**SAN ANTONIO WATER SYSTEM
S. PRESA ST. 48" SIPHON #6 PROJECT
SAWS PROJECT # 11-4514
SAWS Solicitation No. B-11-020-DG
ADDENDUM NO. 1**

MAY 6, 2011

SAN ANTONIO WATER SYSTEM
S. PRESA ST. 48" SIPHON #6 -
SANITARY SEWER IMPROVEMENTS
TRAFFIC CONTROL PLAN

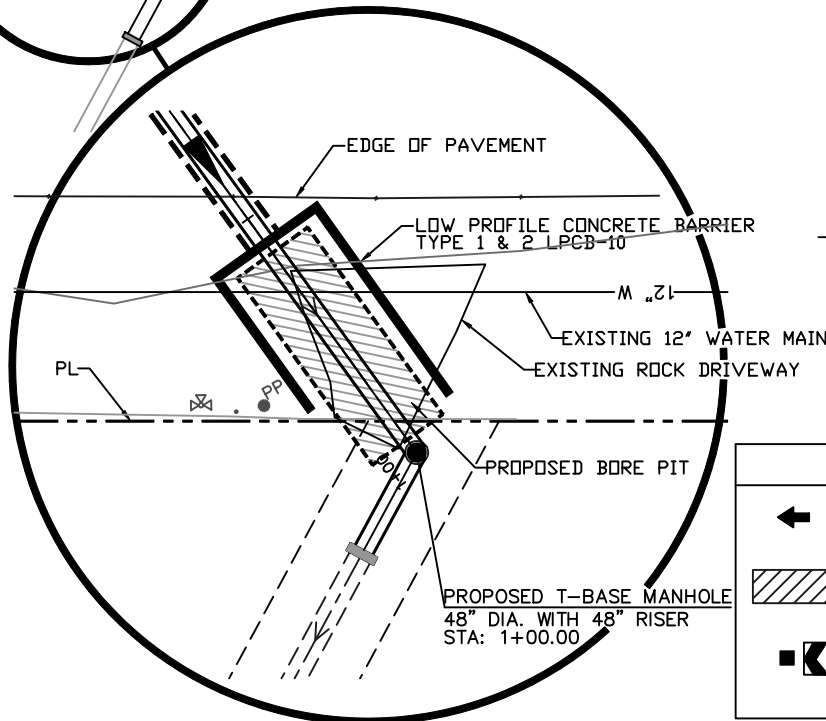
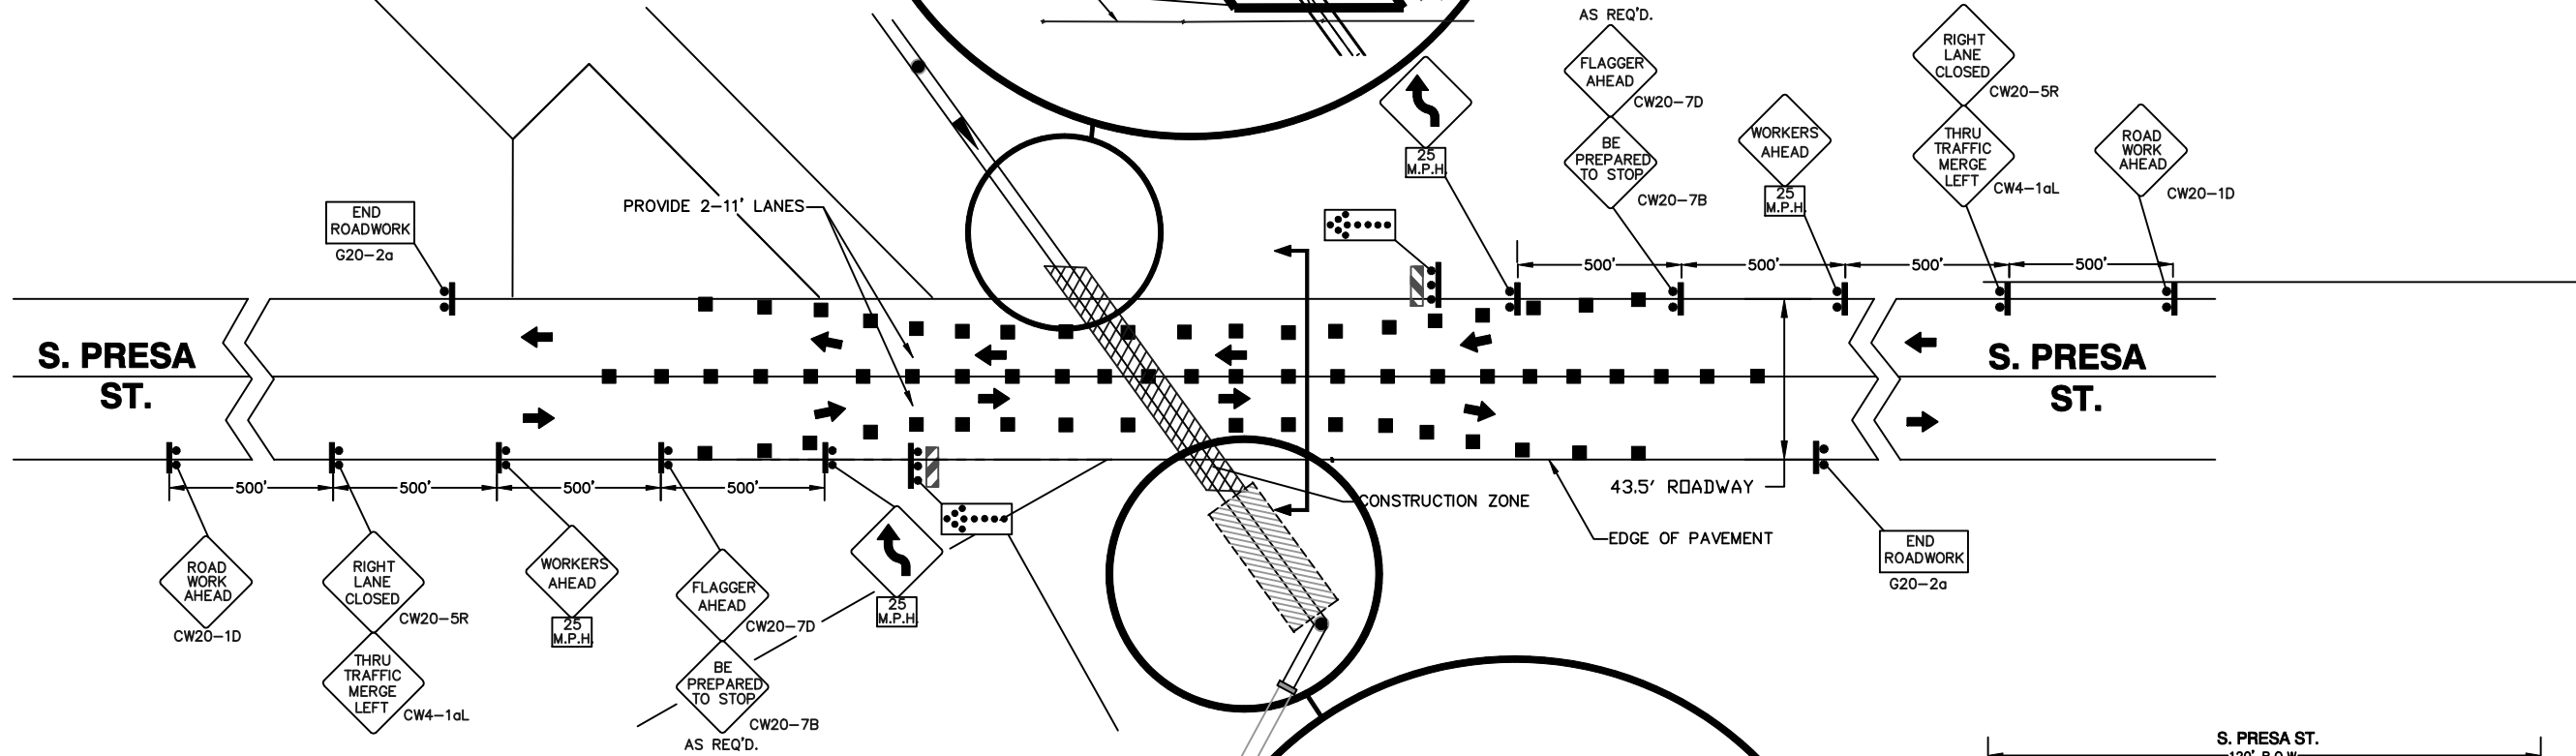
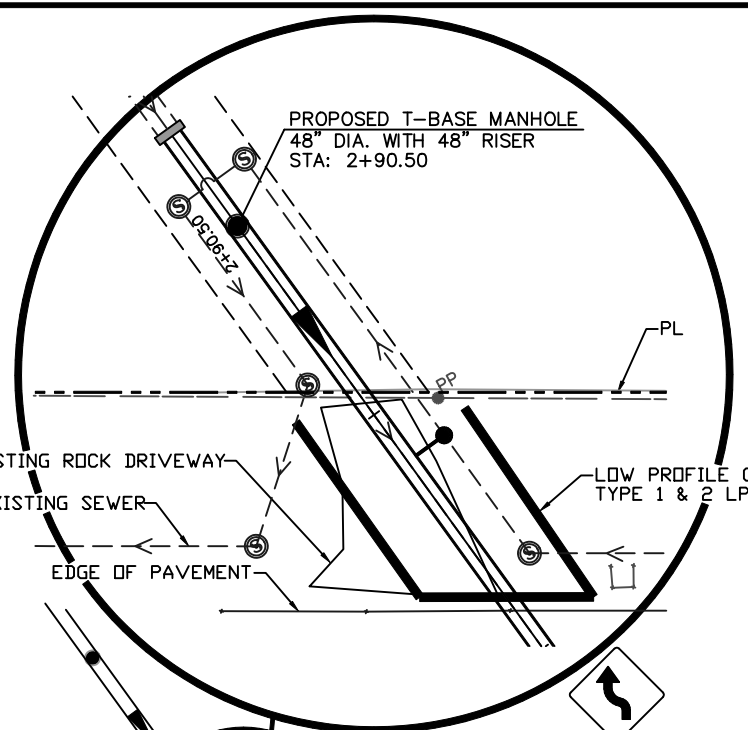
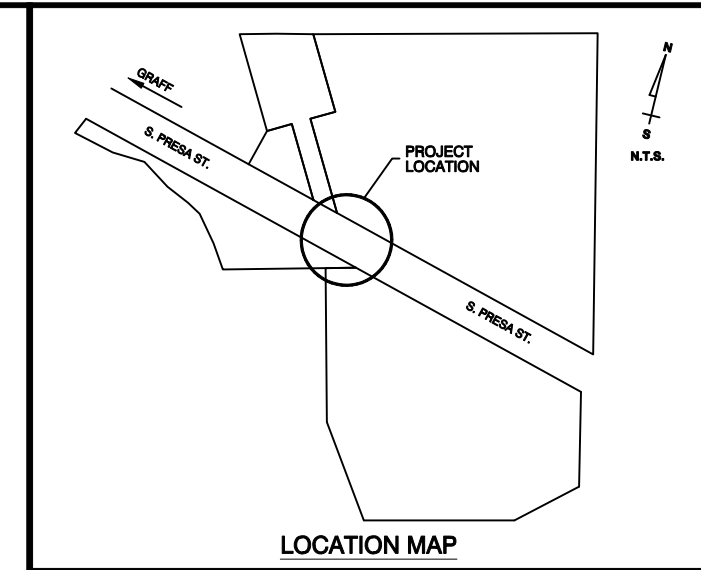
- A3. Yes, attached please find Traffic Control Plans (2) for this project.**
- Q4. What is the existing slope in the 48-inch line that will be replaced ?
